### 3/4.3.7 MONITORING INSTRUMENTATION

#### RADIATION MONITORING INSTRUMENTATION

TITLE  
 CURRENT WNP-2 PARTIAL CONTROL ROOM VENTILATION SYS.

TITLE  
PROPOSED WNP-2 PARTIAL CONTROL ROOM VENTILATION SYS

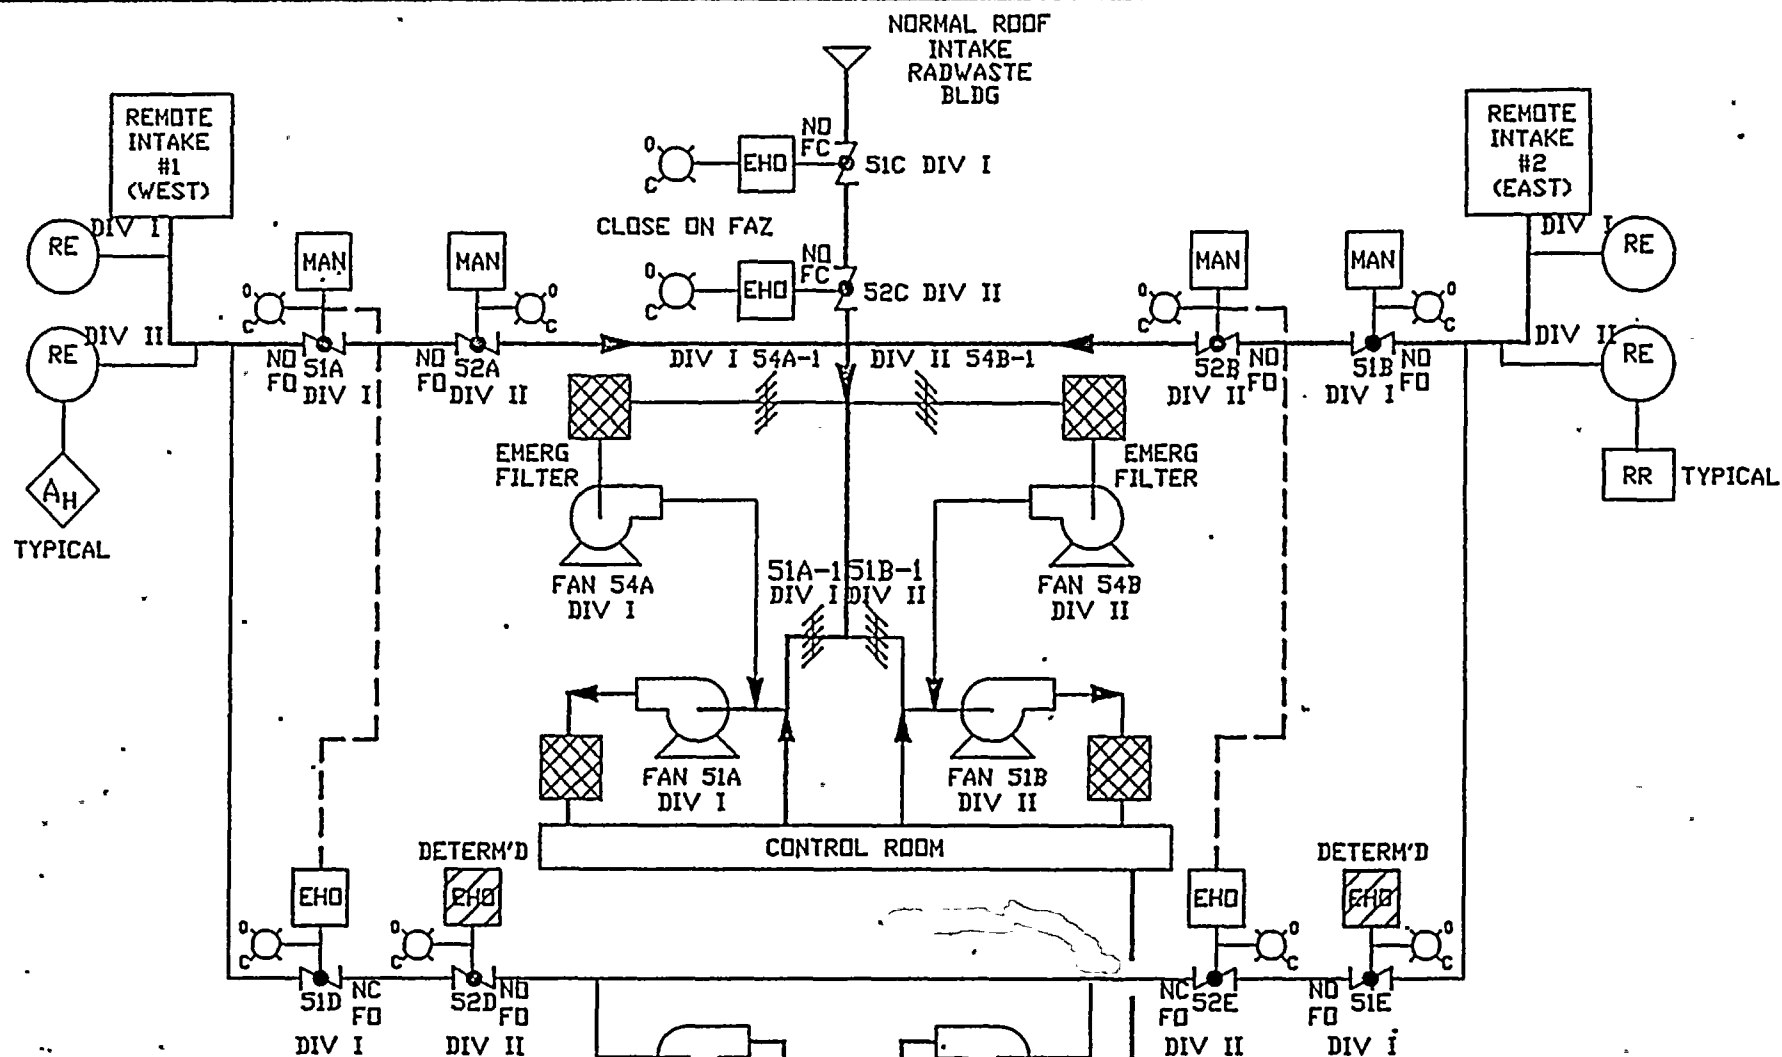
- intake*
- a. With one of the required monitors inoperable, ~~place the inoperable channel in the tripped condition within 1 hour; restore the inoperable channel to OPERABLE status within 7 days, or, within the next 6 hours, initiate and maintain operation of the control room emergency filtration system in the pressurization mode of operation.~~ *manually isolate the associated remote air*
- b. With both of the required monitors inoperable, initiate and maintain operation of the control room emergency filtration system in the pressurization mode of operation within 1 hour.

The OPERABILITY of the radiation monitoring instrumentation ensures that; (1) the radiation levels are continually measured in the areas served by the individual channels; (2) the alarm ~~or automatic action~~ is initiated when the radiation level trip setpoint is exceeded; and (3) sufficient information is available on selected plant parameters to monitor and assess these variables following an accident. This capability is consistent with 10 CFR Part 50, Appendix A, General Design Criteria 19, 41, 60, 61, 63, and 64.
